SUBJECT: Forwards addl info re Mark I torus mods to torus attached piping, as part of containment plant-unique analysis rept, per D Vassallo 840322 request.

Subject: Duane Arnold Energy Center  
Docket No: 50-331  
Op. License No: DPR-49  
Mark I Torus Modifications-Torus Attached Piping  
Reference: NRC Letter, D. Vassallo to L. Liu, dated  
March 22, 1984

RESPONSE TO NRC REQUEST FOR

CONTAINMENT PLANT UNIQUE ANALYSIS REPORT

Figure 1 TRANSFER FUNCTION AND CRITICAL FREQUENCIES ( $f_c$ )

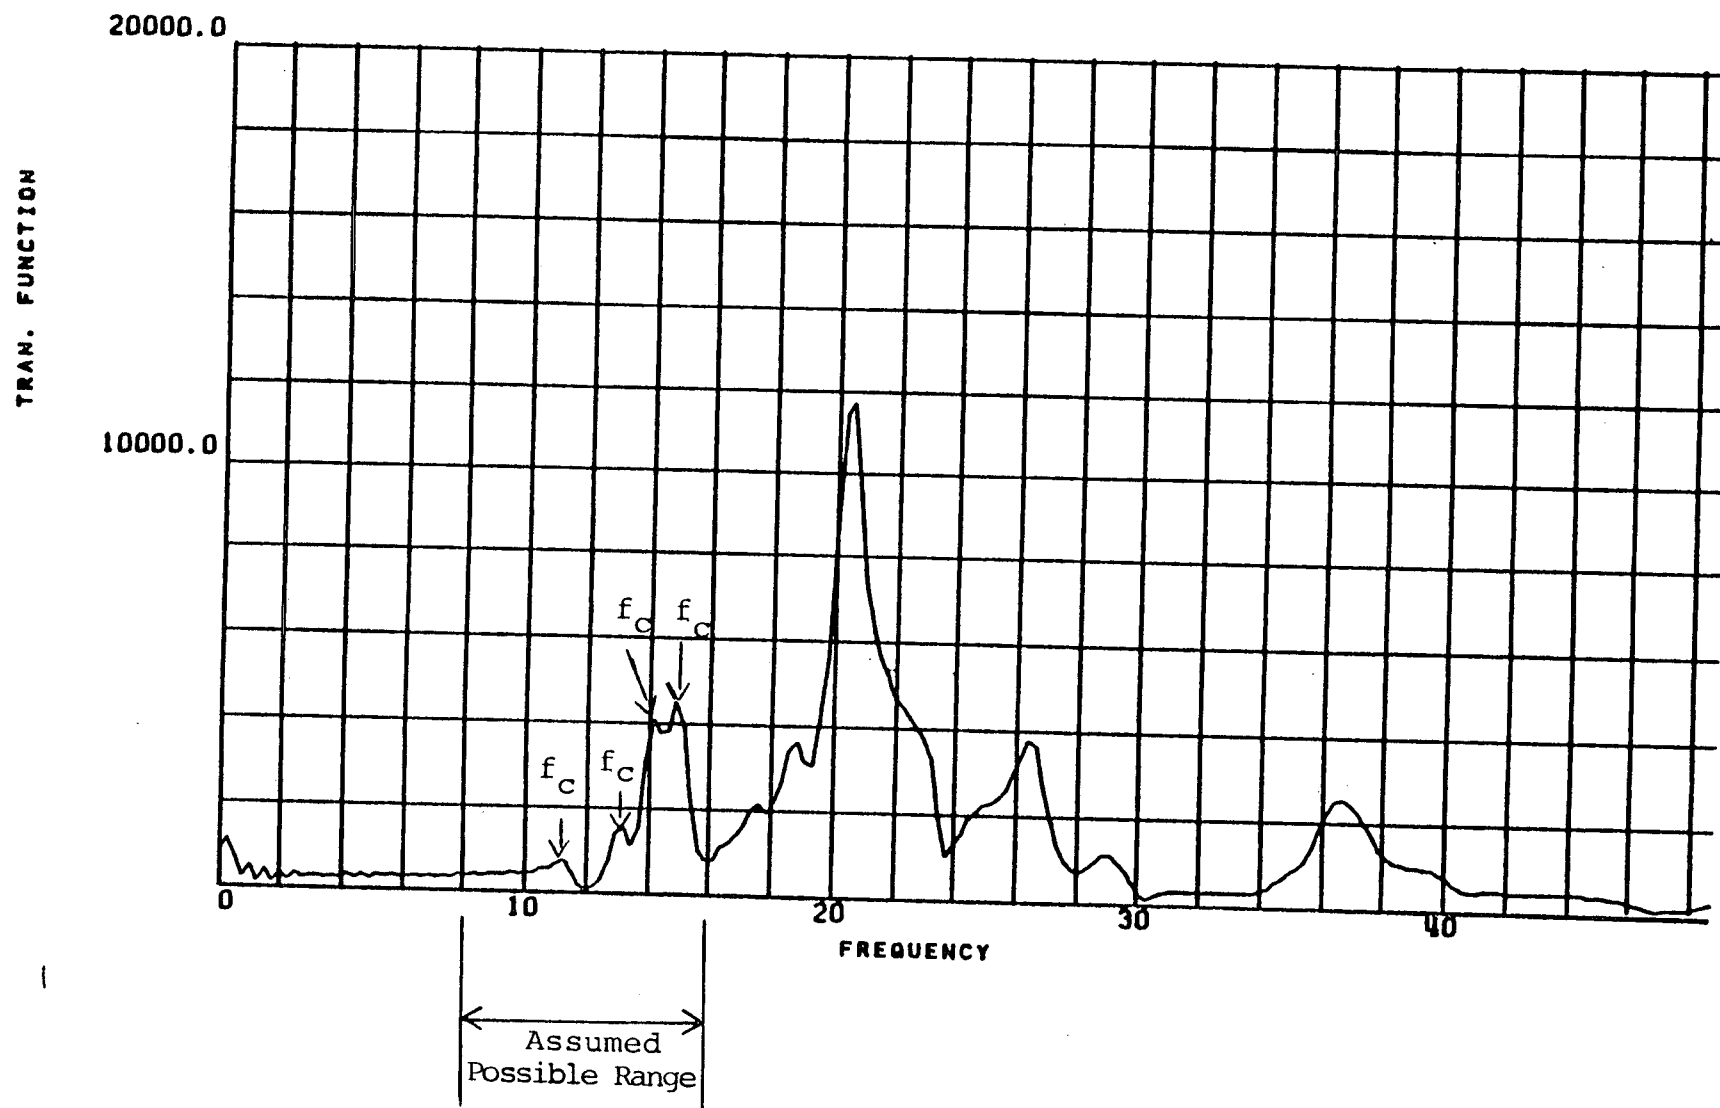
Item 3(d): Show (by some figures) how the critical piping frequencies were obtained from the transfer function based on the prescribed hydrodynamic load frequency range. Also, show how the hydrodynamic load was tuned to the critical piping frequencies.

Response: The transfer function of a piping response component is first calculated and plotted as a function of frequency. Due to the small damping values that are used in the analysis of the piping system, the transfer function plot shows typically sharp peaks and deep valleys. The locations of the peaks (or local maxima) within the prescribed hydrodynamic load frequency range then define the critical frequencies for the piping response component under consideration (see Figure 1). The selection of critical frequencies for the piping analysis or "tuning", is performed by determining those frequencies within the load range with the highest number of peaks.
